MIL-M-28787/135A(SH)
AMENDMENT 2
19 July 1991
SUPERSEDING
AMENDMENT 1
13 November 1981

MILITARY SPECIFICATION

MODULES, STANDARD ELECTRONIC

INDUCTOR, 1.5 AMPERE, POWER, KEY CODE QPM

FIGURE 3 Continuity, DC resistance, frame continuity, and jumper resistance test circuit for tables II, IV, VII, and IX

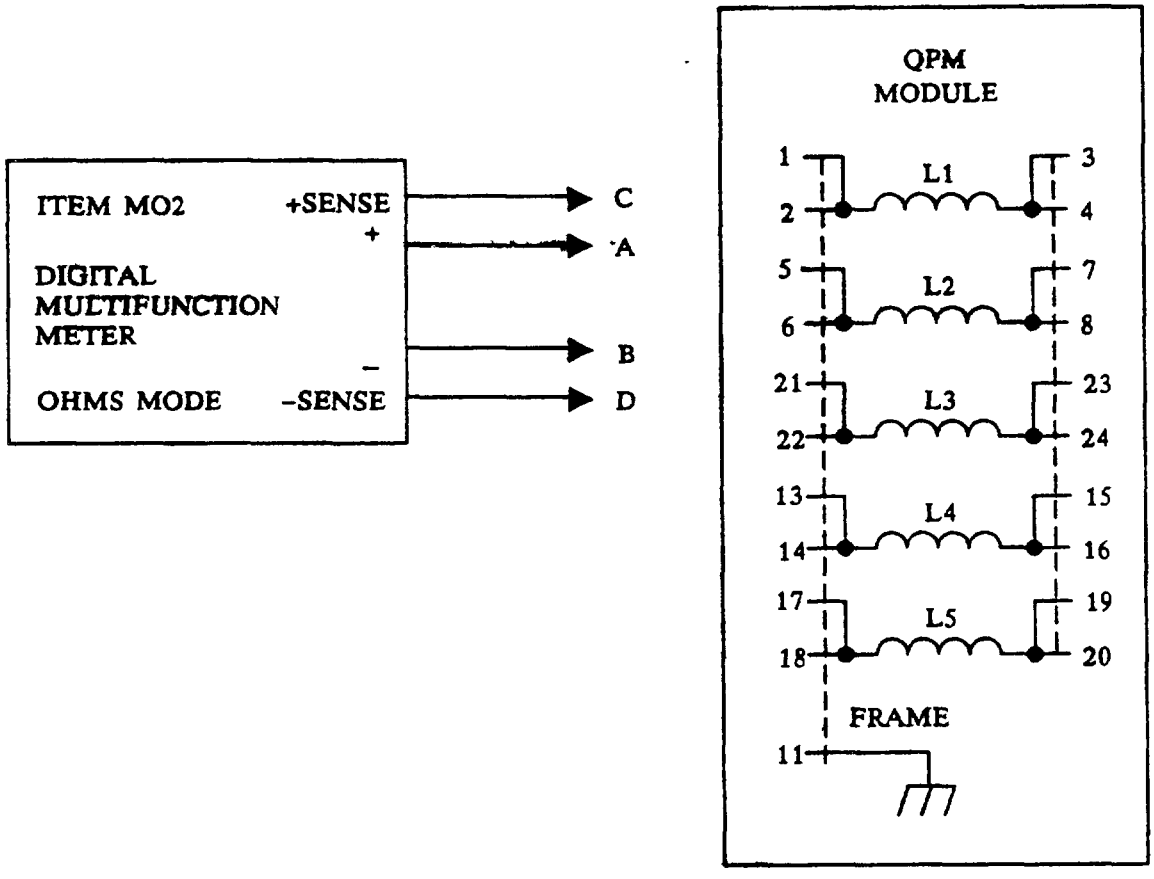
FIGURE 3· Delete and substitute new figure 3 as printed on page 3 of this amendment

NOTES:
1. Each resistance value measured shall be per table I requirements after compensating for TARE in the setup.
2. For test conditions A1-A10, F, and H1-H10, item M02 shall be connected for two wire resistance measurements and points C and D shall not be used
